**moravan · otrokovice · čssr**

**SERVICE BULLETIN Z 326/69  
Z 526/37**  
-----

1. Concerns : All aircraft Z 326, Z 326 A, Z 526, Z 526 A, Z 526 F, Z 526 L, Z 526 AFS, Z 526 AF.
2. Reason : Removal of abnormal clearance in the upper butt hinge of the wing.

Fig.2 (Montage) - Obr. 2 (montáž) - Fig.2 (Installation)  
Abb.2 (Montage) Фиг.2 (монтаж)

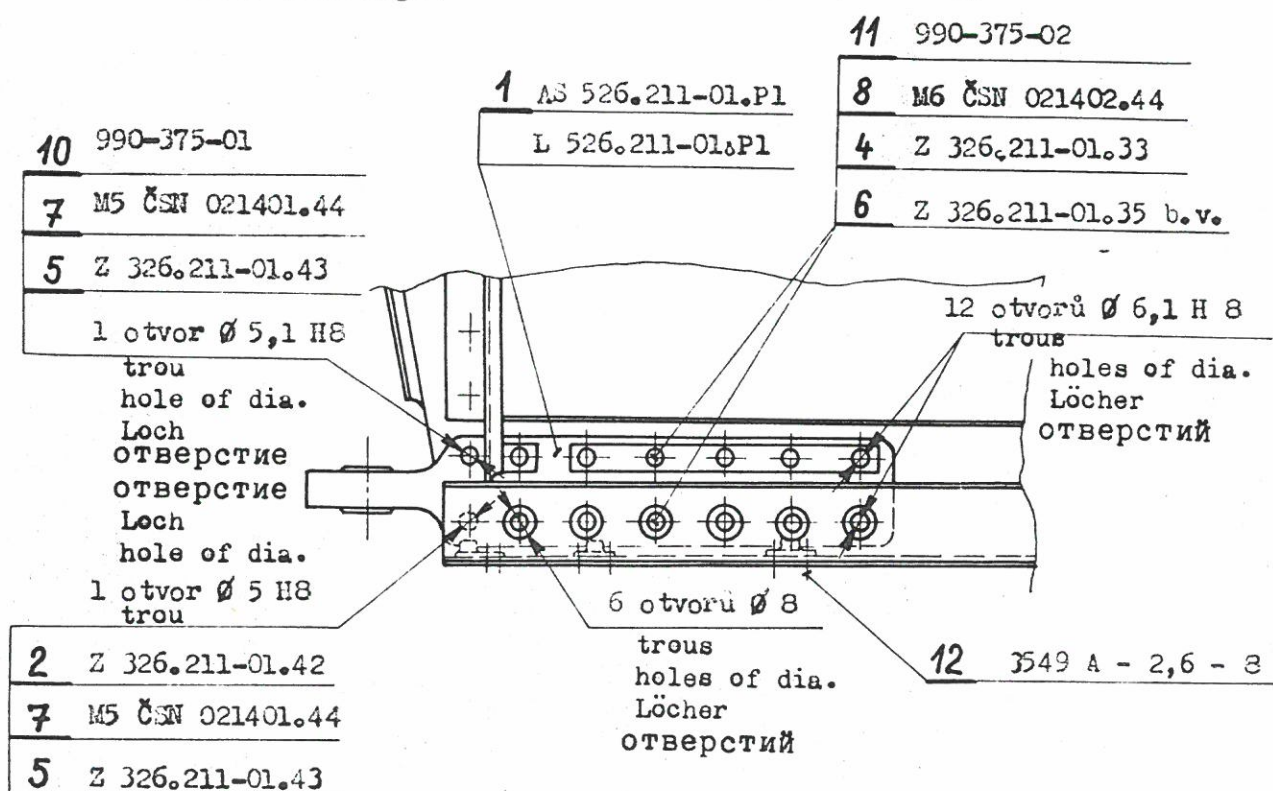
Lay removed wing without fuel tank on prepared stands - see fig.1. To facilitate the access to heads of fitted bolts (ind.No. 2,3) we recommend to disconnect the pull rod of ailerons from the transmission lever and to insert it in the wing in order not to hinder from work. Remove 2 nuts M 5 (ind. No.7), 2 shims (ind.No.5) and 12 nuts M 6 (ind. No.8), 2 shims (ind. No.4) by aid of eye spanner and fork spanner. Mark shims (ind.No. 4,5) so that you can put them on original place when installing new attachment fitting. Knock out 2 fitted bolts of dia. 5 (ind. No. 2), 12 fitted bolts of dia. 6 (ind. No. 3) and remove attachment fitting (ind. No. 1) from the wing. Mark again further 2 shims (ind. No. 5), 2 shims (ind. No. 4) and 2 plates (ind. No. 6). Drill off rivets on 2 anchor nuts (ind. No. 9) using a drill of dia. 2.7 mm and remove them from the wing. In prolongation of axis of holes for fitted bolts, drill 6 holes of dia. 8 into a stiffener on the wing - see fig. 2. In a new attachment fitting (ind. No. 1), reream a marginal hole of lower row from dia. 4.8 mm to dia. 5 H 8 for a new fitted bolt (ind. No. 2). Slide on this new attachment fitting on the spar web and set plates (ind. No. 6) and shims (ind. No. 4,5) on original places in accordance with markings. Install new fitted bolt of dia. 5 (ind. No. 2), new M 5 nut (ind. No. 7) and tighten after installation of the fitting. Ream last hole in the upper row to dia. 6.1 H 8, install new fitted bolt of dia. 6.1 (ind.No. 11) new M 6 nut (ind. No. 8) and tighten them. Ream remaining holes to dia. 6.1 H 8, one hole to dia. 5.1 H 8 - see fig. 2. When reaming lower row, utilize drilled holes of dia. 8 in the stiffener on the wing. Install new fitted bolts of dia. 6.1 (ind. No. 11), new nuts M 6 (ind. No. 8), and fitted bolt of dia. 5.1 (ind. No. 10) with a new nut M 5 (ind. No. 7). After tightening, secure nut by means of three centre-punches. Rivet again nuts (ind. No. 9) with the use of rivets 3549 A - 2.6 - 8. Do not forget to connect the pull rod of ailerons to the transmission lever. In case of the second replacement of the attachment fitting, proceed in the same way. Apply, however, fitted bolts of dia. 6.2 draw.No. 990-375-04 and dia. 5.2 draw. No. 990-375-03. Ream then holes to dia. 6.2 H 8 and dia. 5.2 H 8.

Ind. No.			Assy units
1	Attachment fitting upper for bolts of wing of dia. 18	AS 526.211-01.P1	1
	Attachment fitting upper for bolts of wing of dia. 20	L 526.211-01.P1	1
2	Fitted bolt of dia. 5	Z 326.211-01.42	1
10	Fitted bolt of dia. 5.2	990-375-03	1
11	Fitted bolt of dia. 6.2	990-375-04	12
7	Nut	M 5 ČSN 021401.44	2
8	Nut	M 6 ČSN 021402.44	12
12	Countersunk-head rivet	3549A - 2.6 - 8	4

Abb. 1  
Fig. 1  
Fig. 1

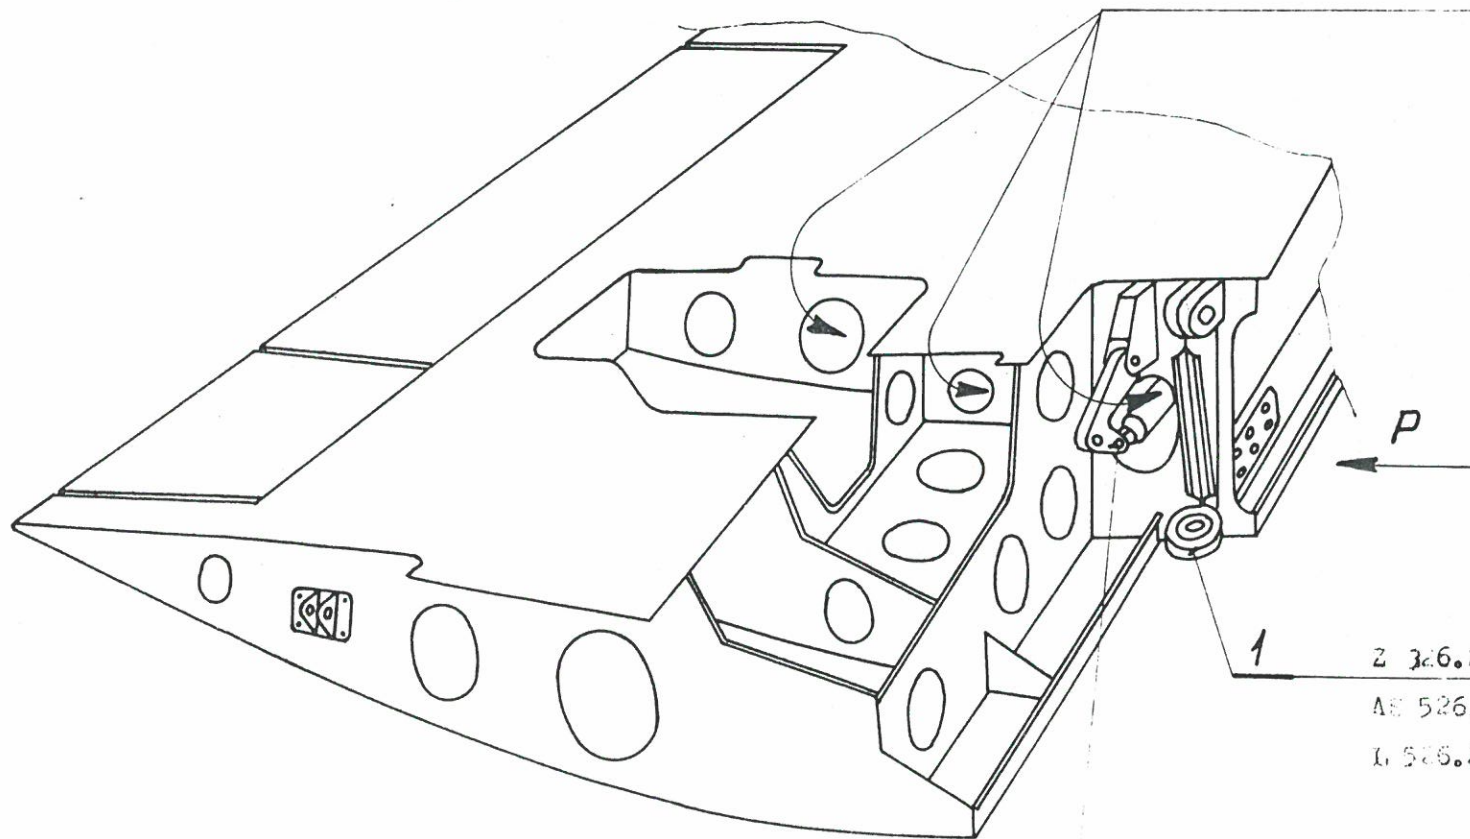
Holes for access to heads of fitted bolts

Disconnect pull rod of aileron from transmission lever
